SUBJECT: TECHNICAL SPECIFICATION CHANGE FOR SECTION 6 -
ADMINISTRATIVE CONTROLS (TAC 00124, 00125, 00143, 00144)

Re: Sequoyah Nuclear Plant, Units 1 and 2

The Commission has issued the enclosed Amendment No. 58 to Facility Operating License No. DPR-77 and Amendment No. 50 to Facility Operating License No. DPR-79 for the Sequoyah Nuclear Plant, Units 1 and 2, respectively. These amendments are in response to the Tennessee Valley Authority (TVA), the licensee, application dated May 18, 1987 as supplemented by letter dated June 4, 1987. The May 18, 1987 submittal also withdrew all previous submittals for the Administrative Controls technical specifications.

FIGURE 6.2-1 OFFISTE ORGANIZATION FOR FACILITY MANAGEMENT AND TECHNICAL SUPPORT

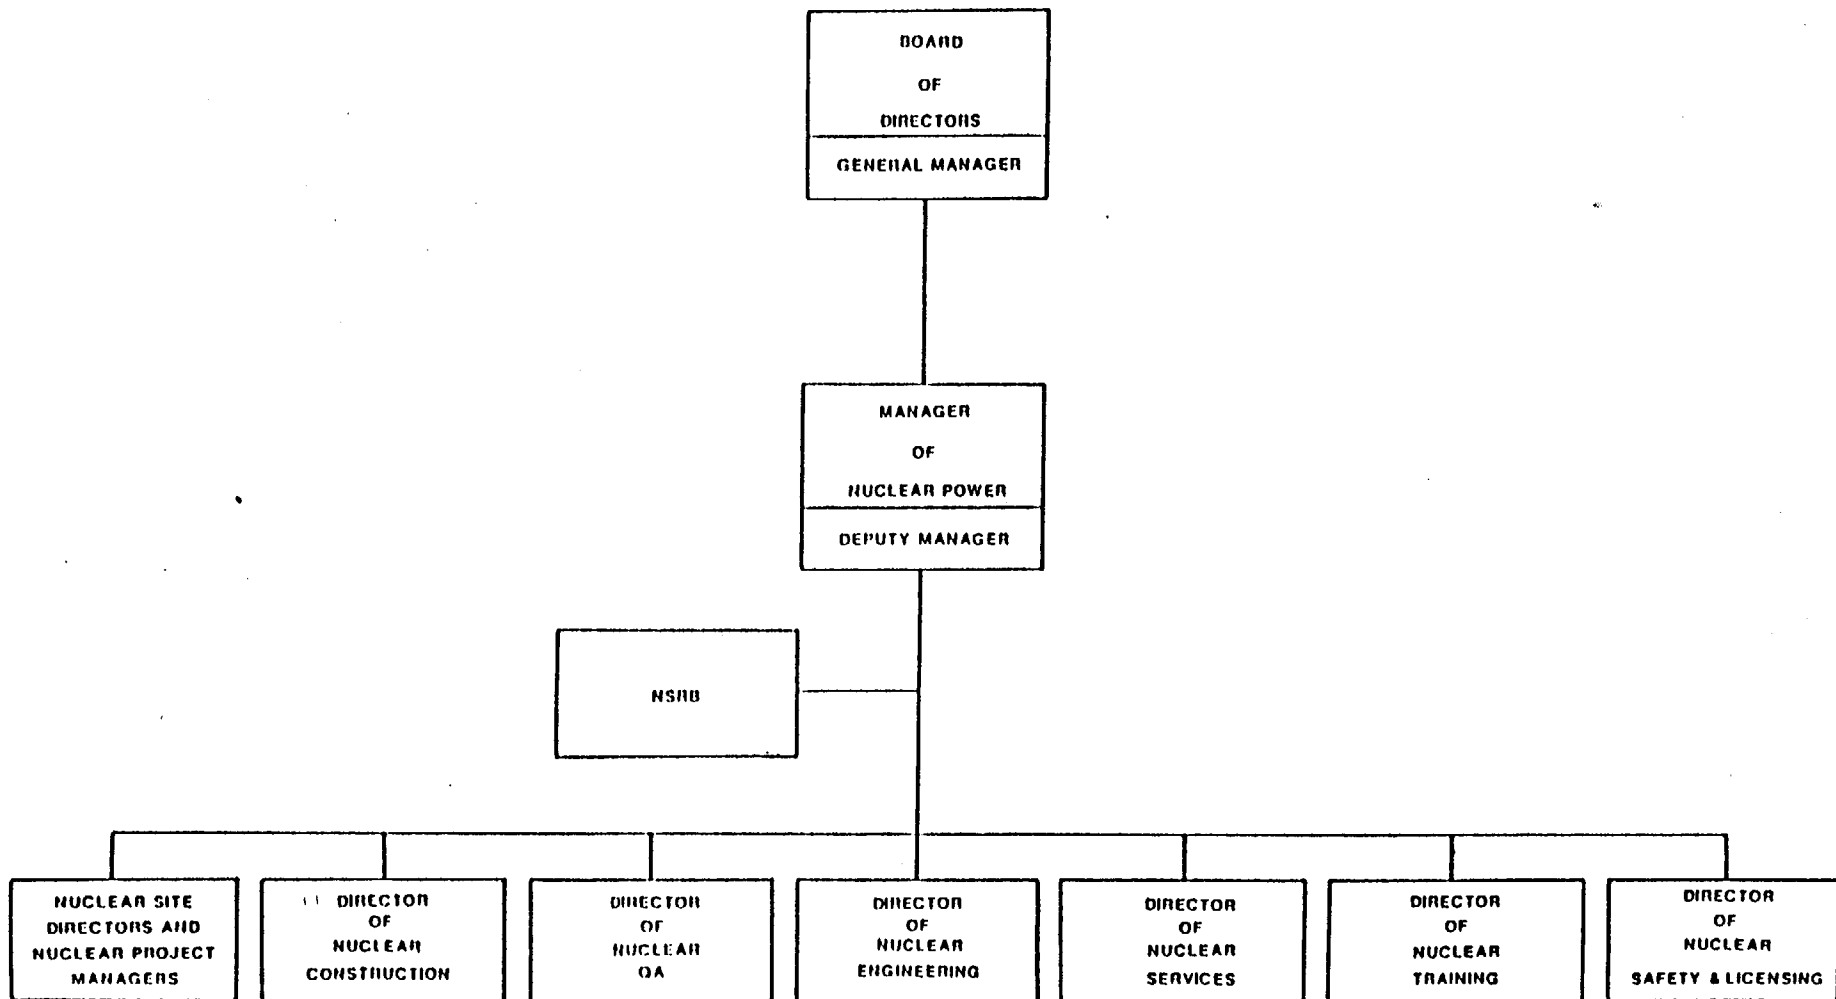
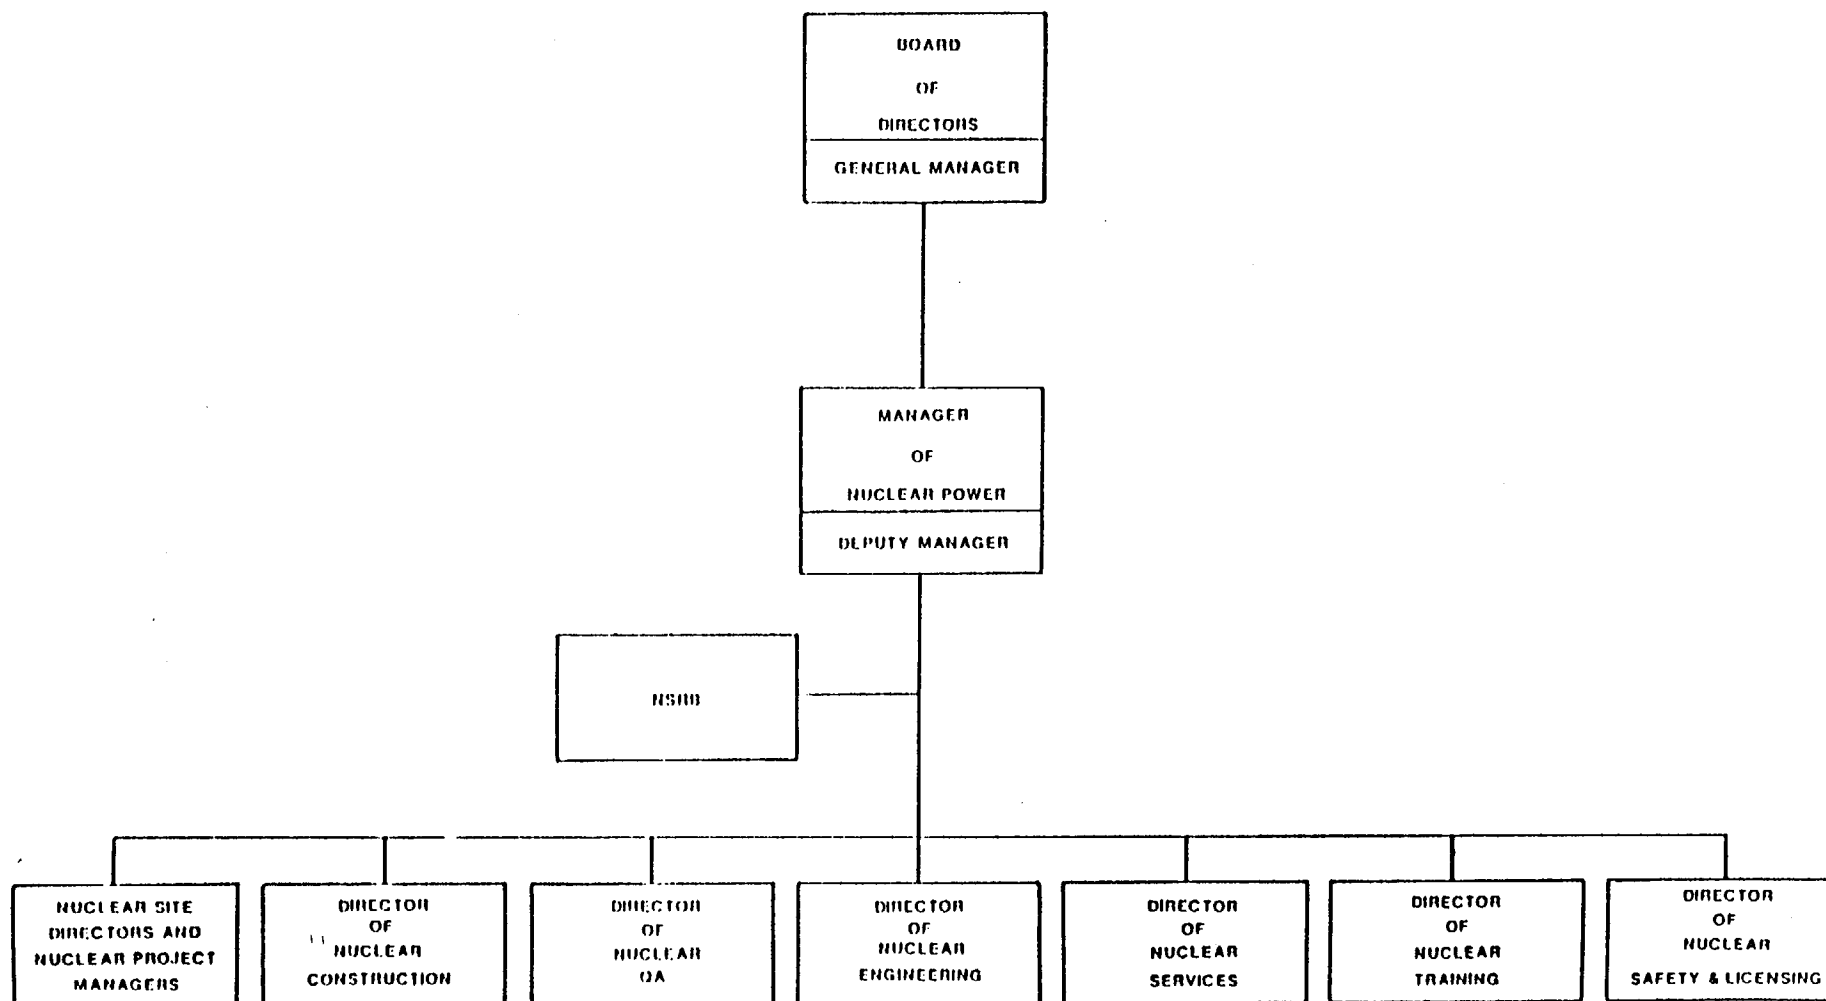
Figure 6.2-1 is revised to reflect the TVA corporate offsite nuclear organization for facility management and technical support. The corporate level changes represent a restructuring of the corporate offsite organization to provide for centralized direction and control of nuclear activities. Each of the offsite corporate departments shown in Figure 6.2-1 will be responsible for direct support of the sites in their areas of responsibilities. The TVA corporate organization was developed so that support to each of the sites follows clear lines. The new figure describes the new TVA offsite nuclear organization, as detailed in Revision 4 of the TVA Corporate Nuclear Performance Plan (March 26, 1987). The staff has reviewed this revised organization and has found it acceptable (NUREG-1232). The Technical Specification change to include the new organization meets the acceptance criteria of Sections 13.1.1 and 13.1.2 of the Standard Review Plan (SRP) and is, therefore, acceptable.

FIGURE 6.2-2
FACILITY ORGANIZATION - SEQUOYAH NUCLEAR PLANT

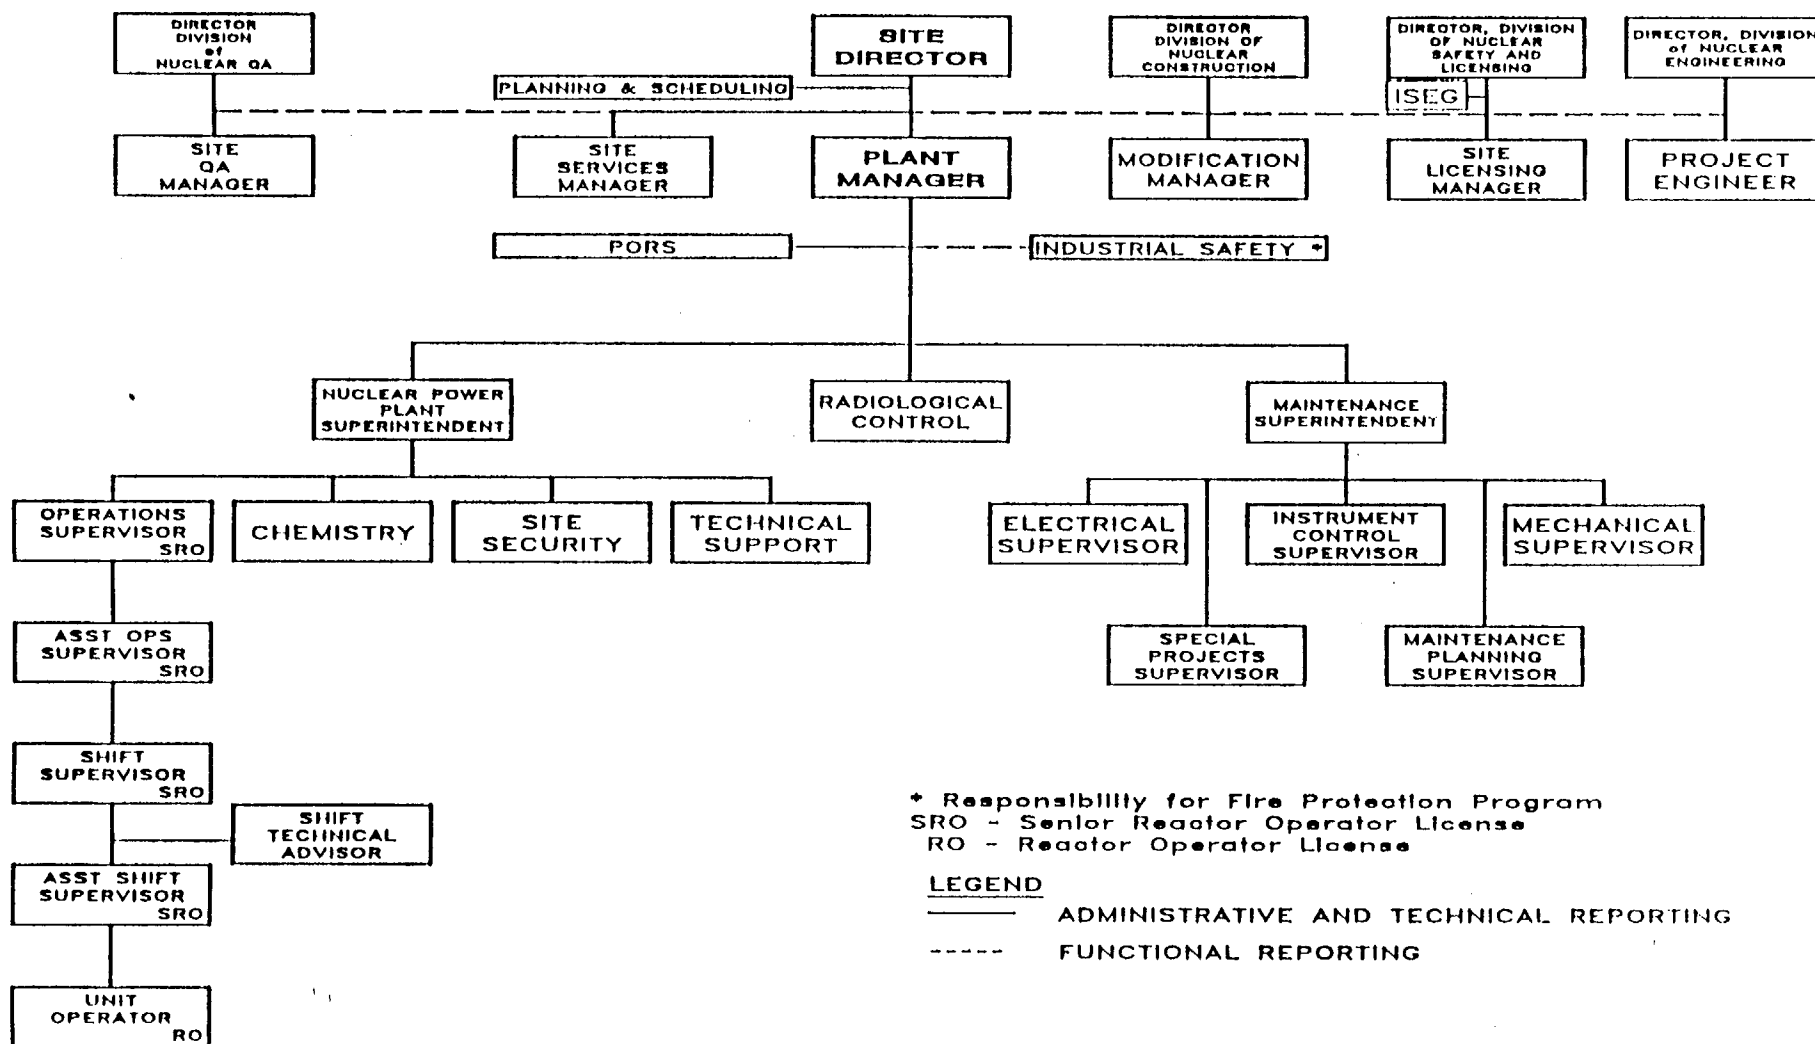
Figure 6.2-2 is revised to reflect the new TVA site organization for Sequoyah, as detailed in the latest revision of the Sequoyah Nuclear Performance Plan (SQNPP), Volume 2, submitted to NRC on April 1, 1987. The Sequoyah site support organization has been reorganized into functional departments that generally parallel the functional departments in the headquarters of the Office of Nuclear Power. The SQNPP describes the plan for providing management control and performing specific actions to correct past problems at Sequoyah. Specifically, the SQNPP outlines the management approach for overcoming past problems and improving regulatory performance at Sequoyah. This TS change revises the organization chart in the TS to be consistent with the organization necessary to carry out the improvements specified in the SQNPP.

In conclusion, Figure 6.2-2 represents the Sequoyah organization which (1) reflects an increase in staffing, (2) provides a higher level of management control at the site, (3) shows improved management involvement in plant operations, (4) has distinct functional areas that are separately supervised, (5) meets the acceptance criteria of Section 13.1.2 of the Standard Review Plan (SRP) and (6) is consistent with the Sequoyah organizational structure presented in the SQNPP. Therefore, the changes to Figure 6.2-2 are acceptable.
